COPPERSTRING 2032

HUGHENDEN - CAMP & LAYDOWN

Non-Resident Worker Accommodation

PRELIMINARY BCA ASSESSMENT:
Trident Job #: Q20230545

drawing **Setout Plan**
 scale 1:750 (A3 paper)
 date 06.09.2023
 dwg # CU2-HU00-DRG-PAS-400-0004_02

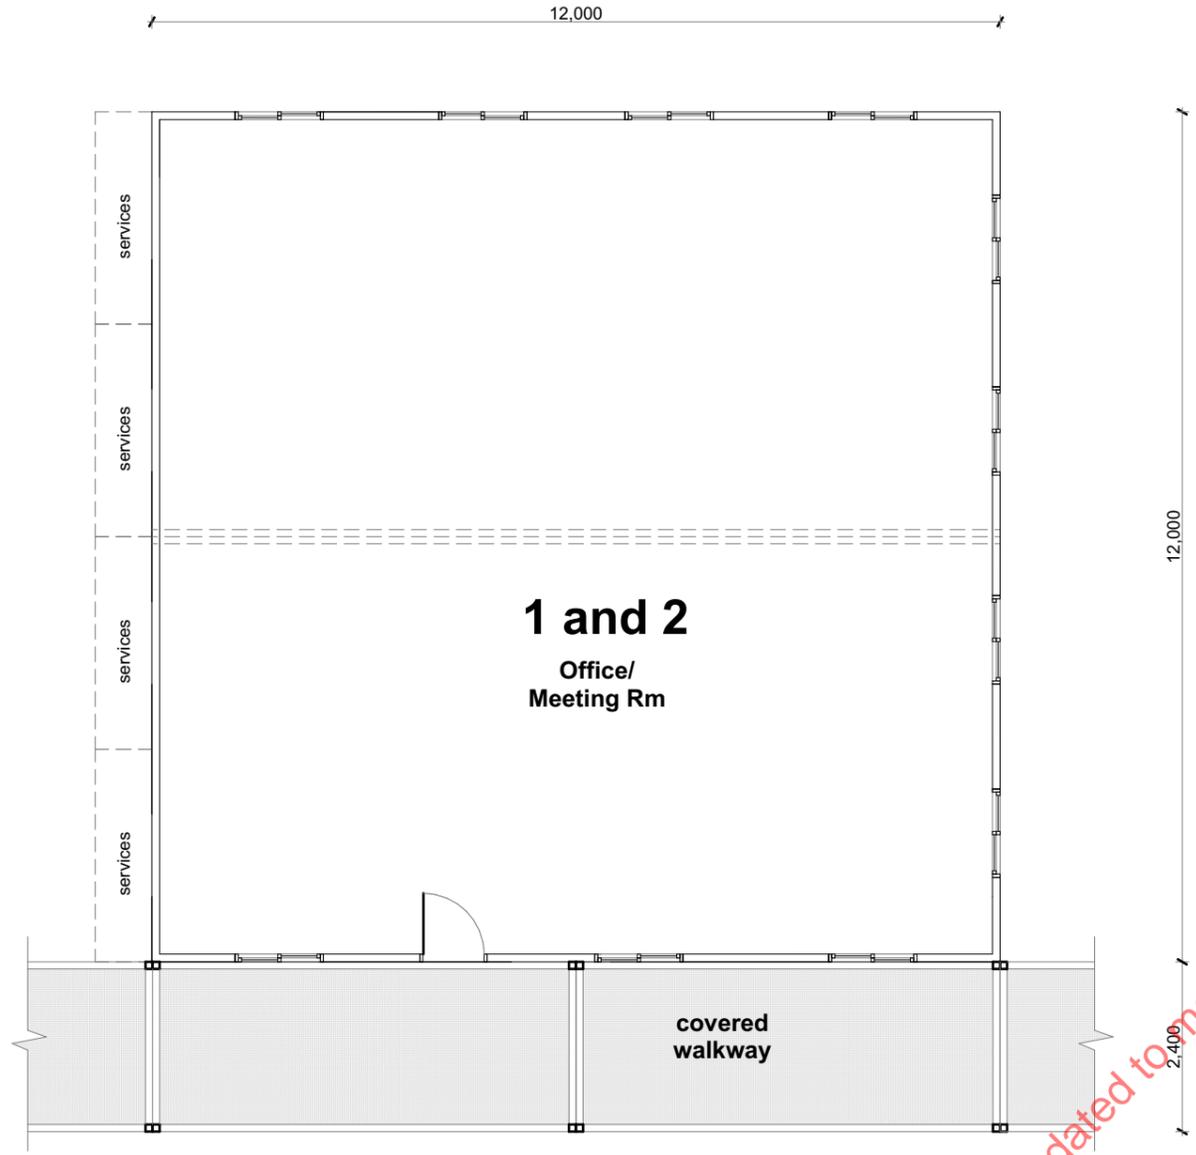
Drawings to be updated to match revised Camp layout per Stormwater Management Plan

drawing **Module 12, 13, 14 - Plans and Elevations**

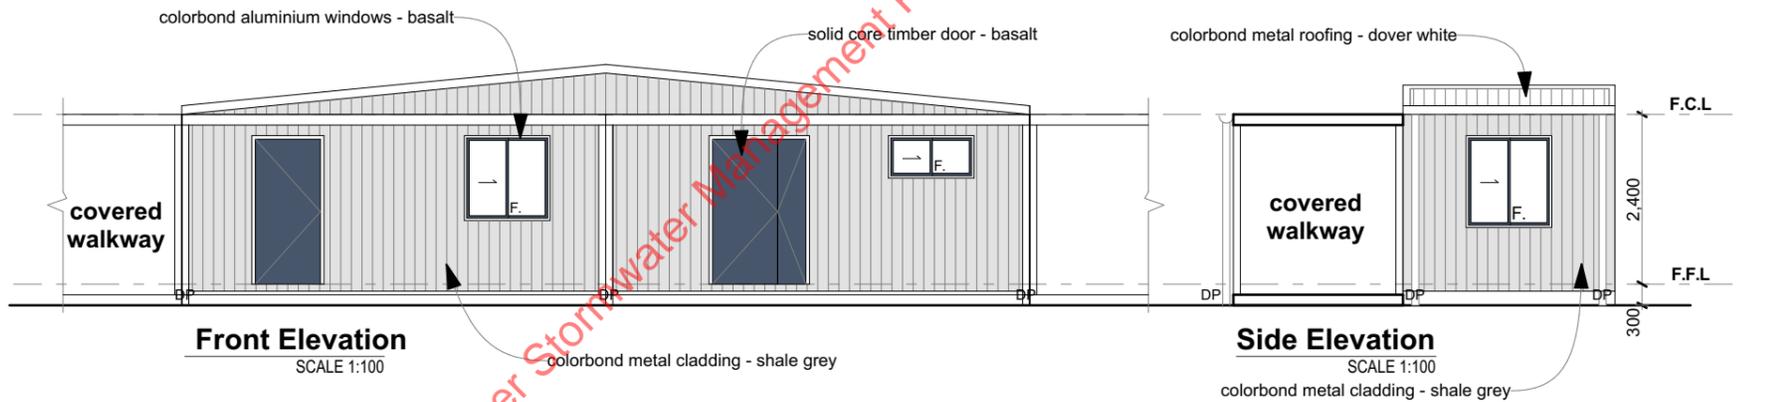
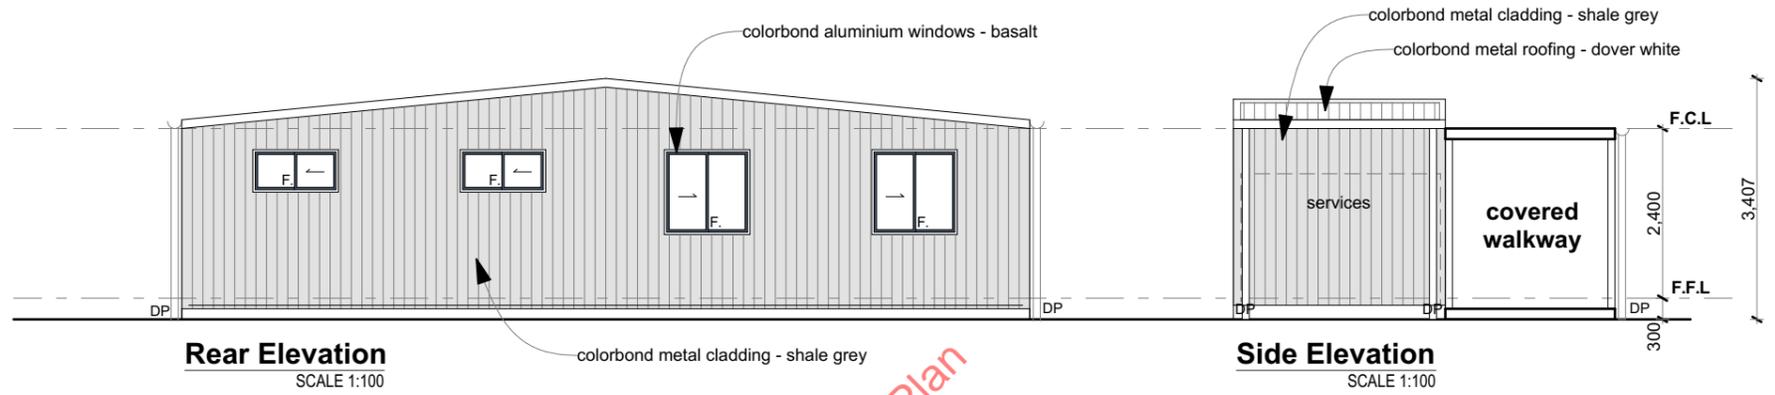
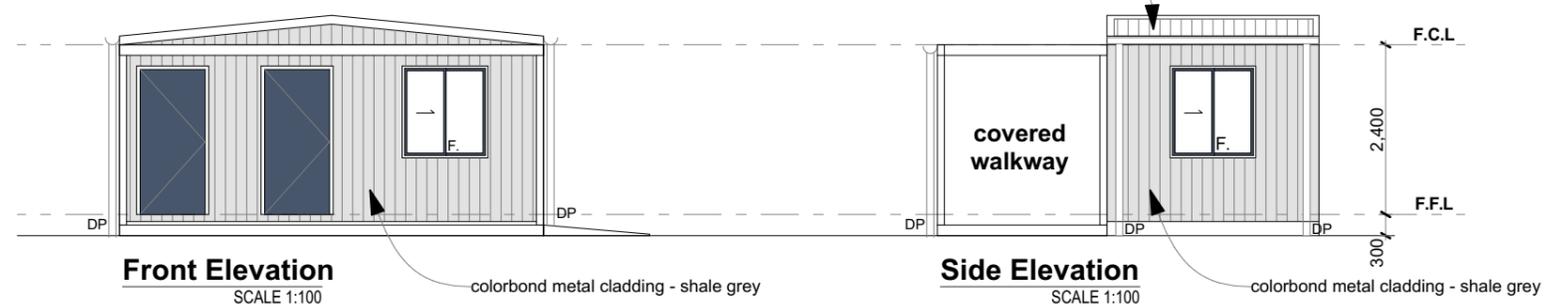
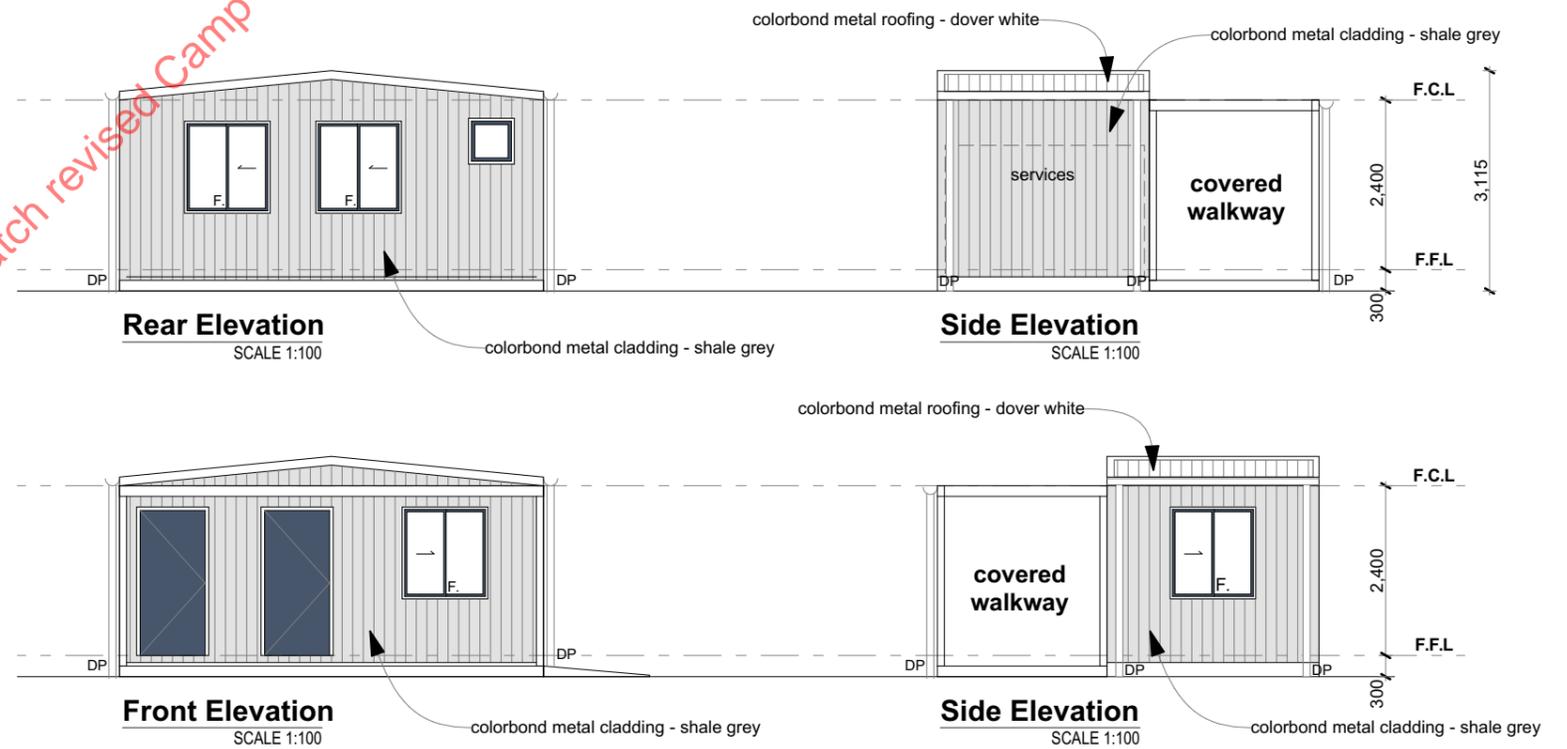
Drawings to be updated to match revised Camp layout per Stormwater Management Plan

drawing **Modules 16,18 - Plans and Elevations**
scale 1:100 (A3 paper)
date 06.09.2023

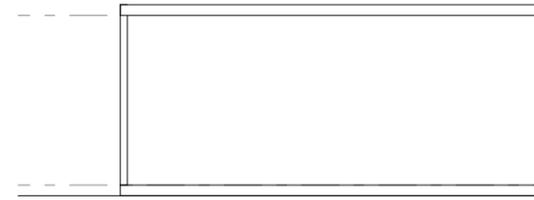
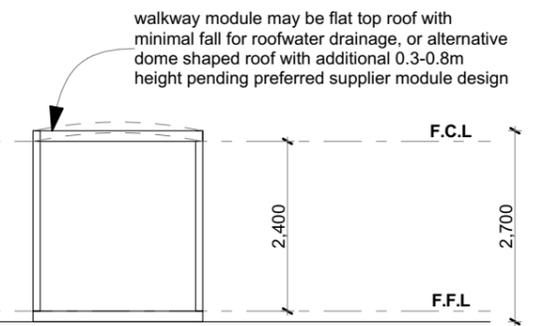
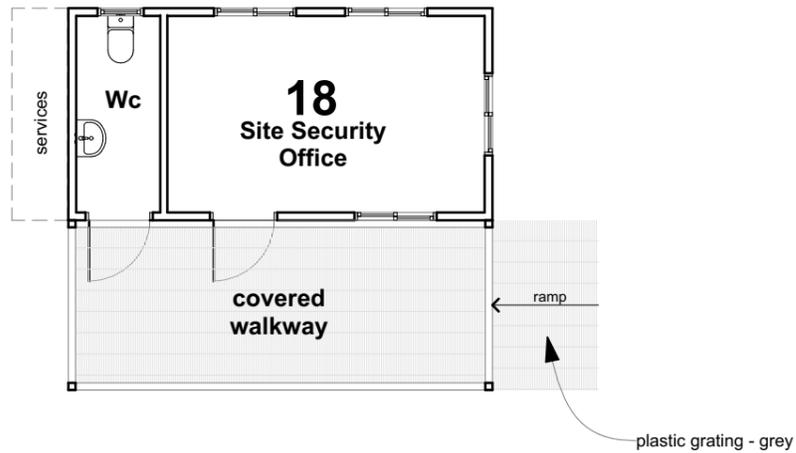
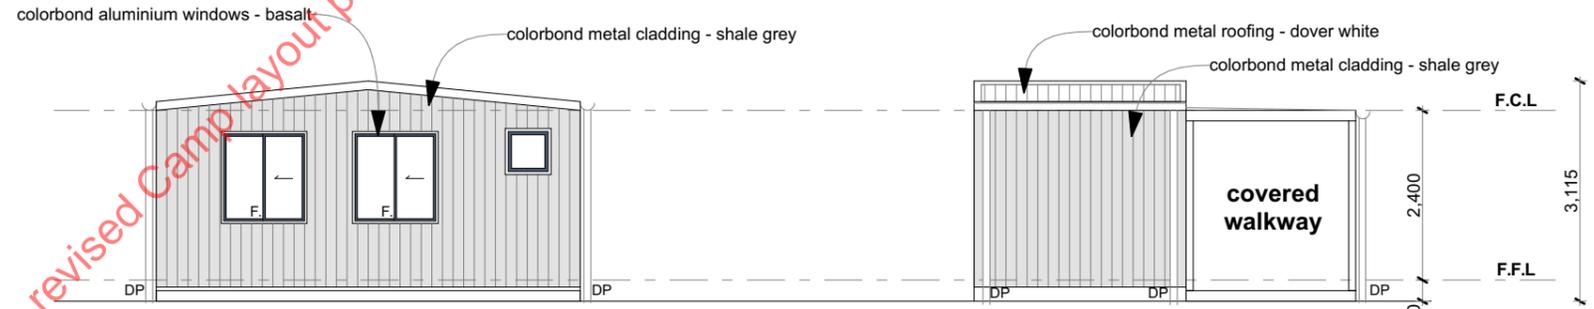
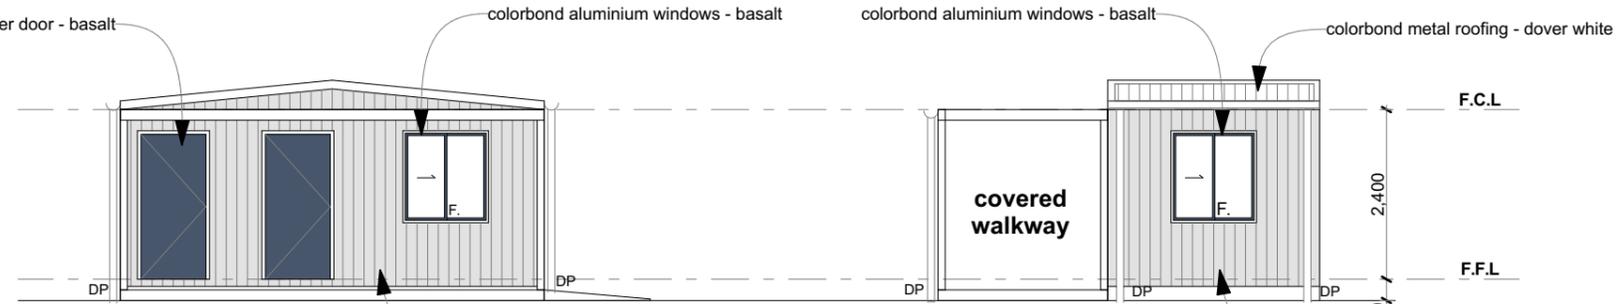
Drawings to be updated to match revised Camp layout per Stormwater Management Plan

drawing **Egress Diagram**

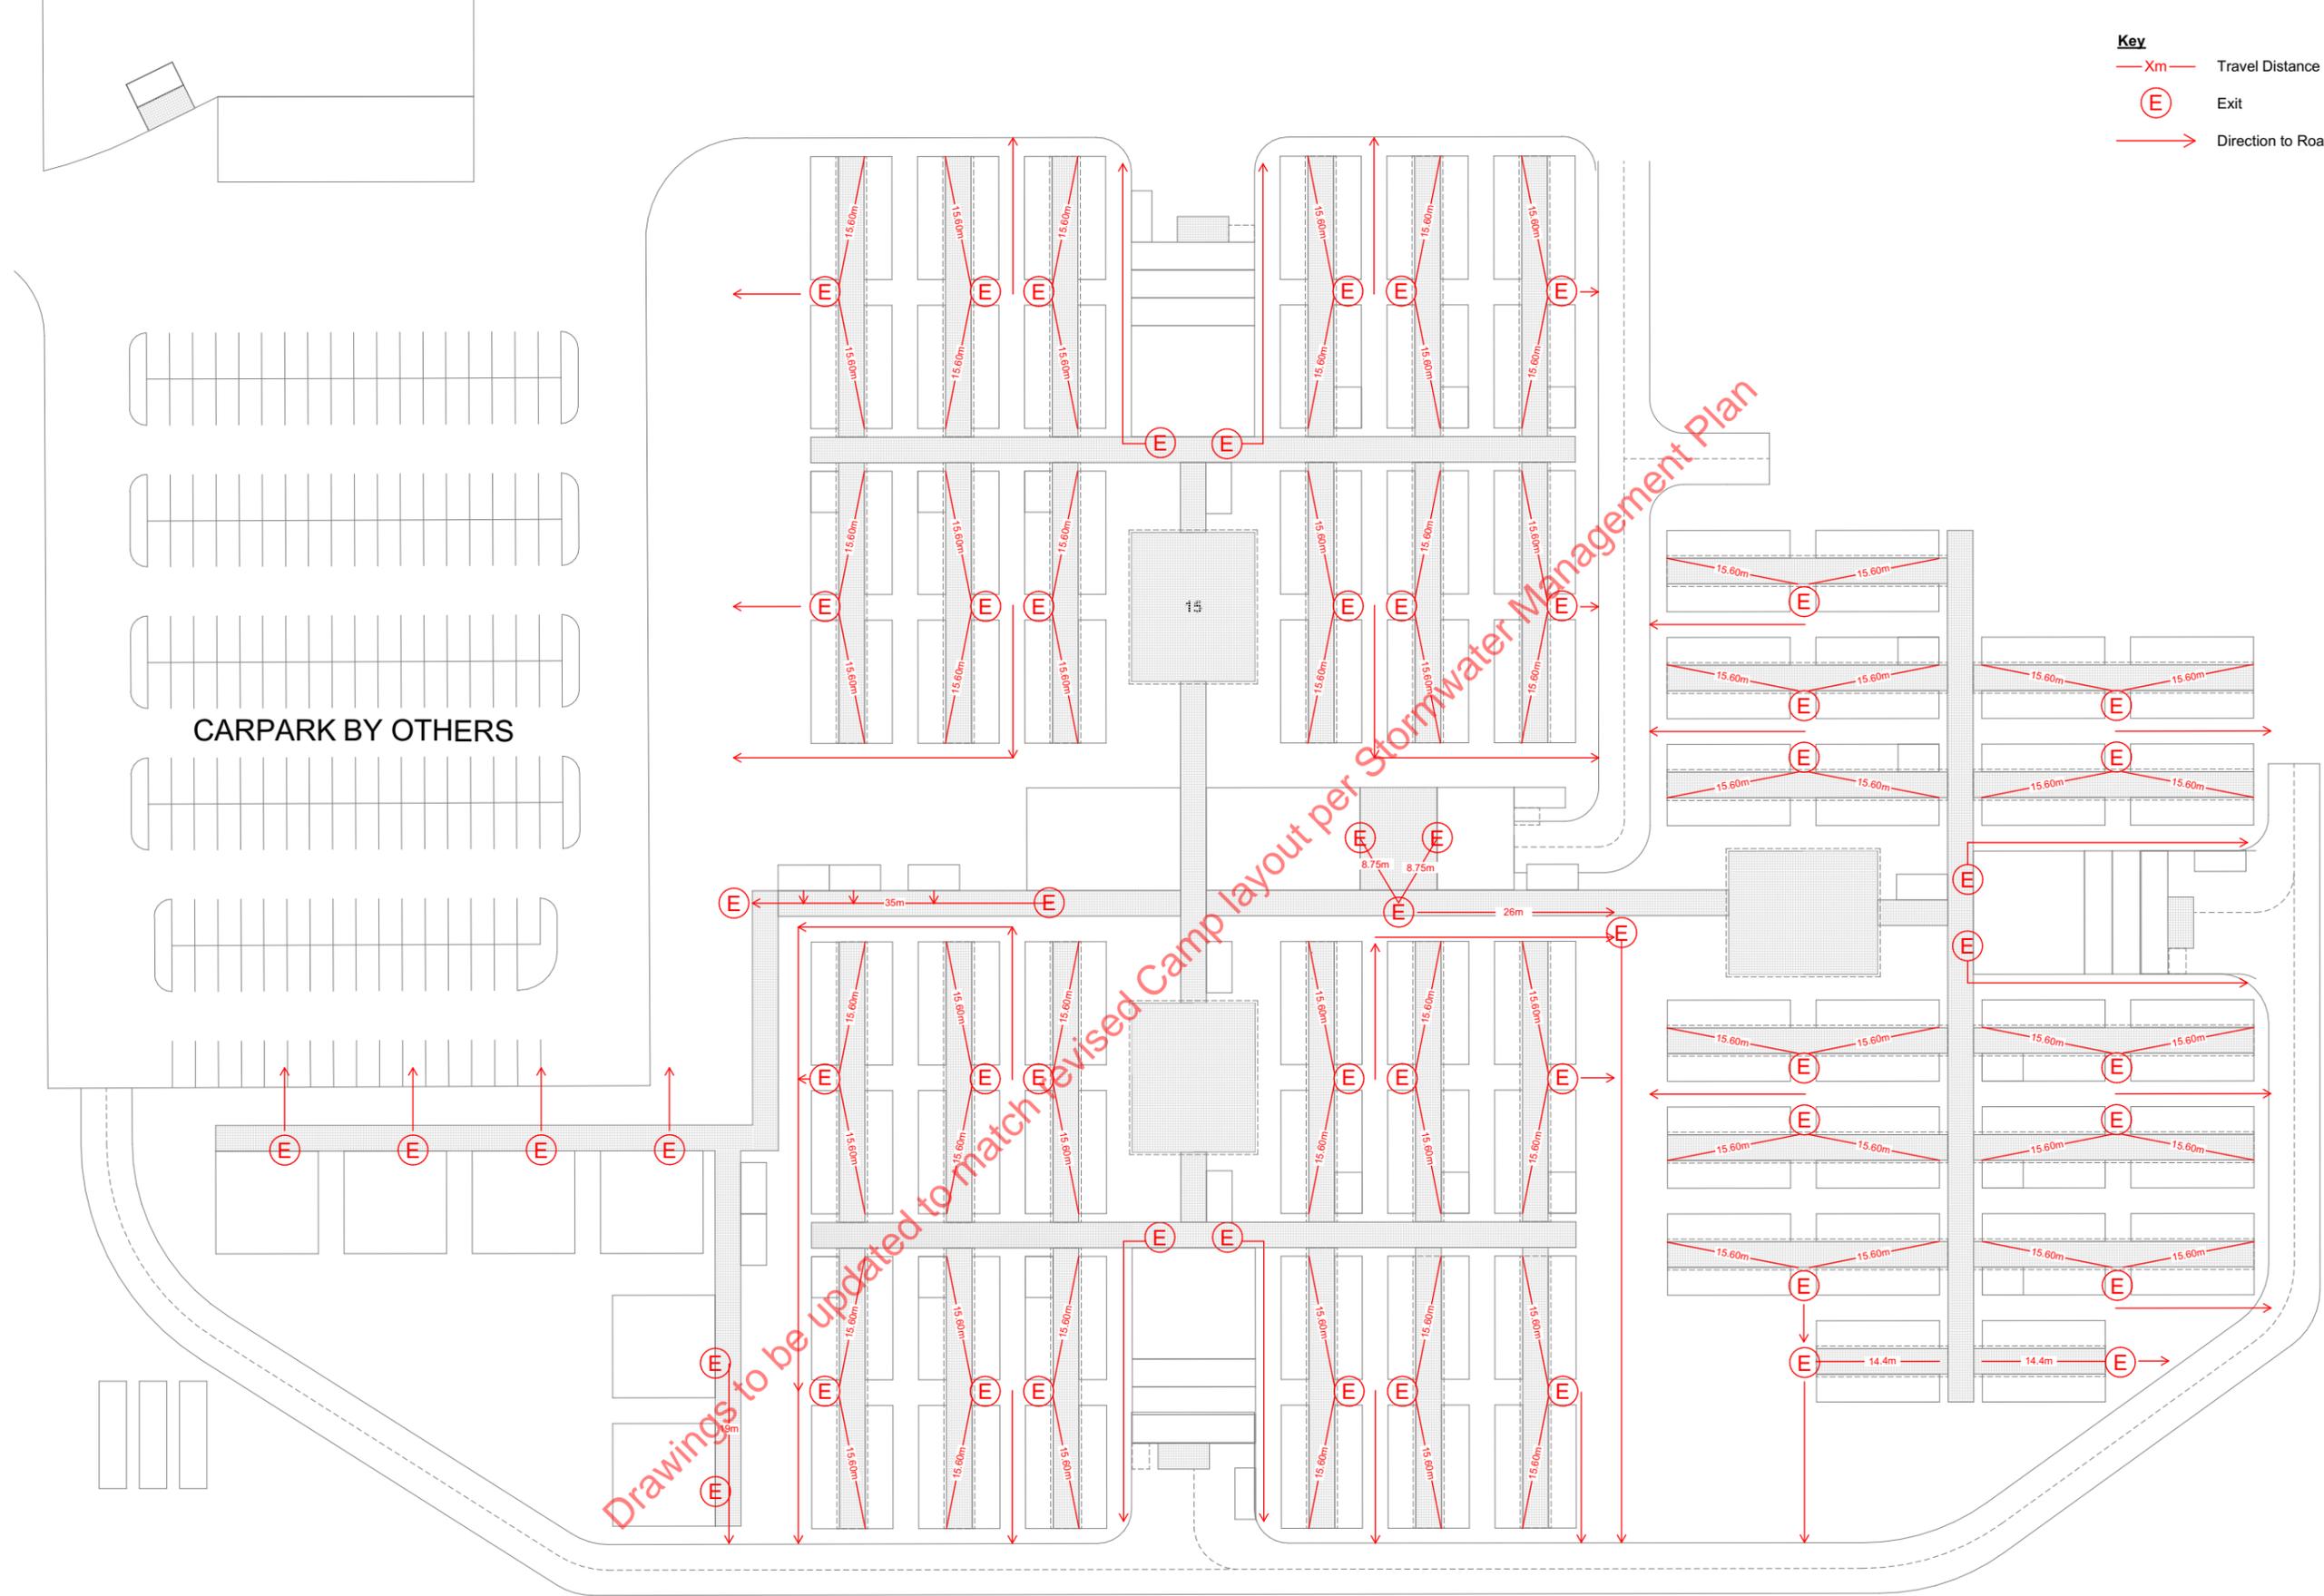
Drawings to be updated to match revised Camp layout per Stormwater Management Plan
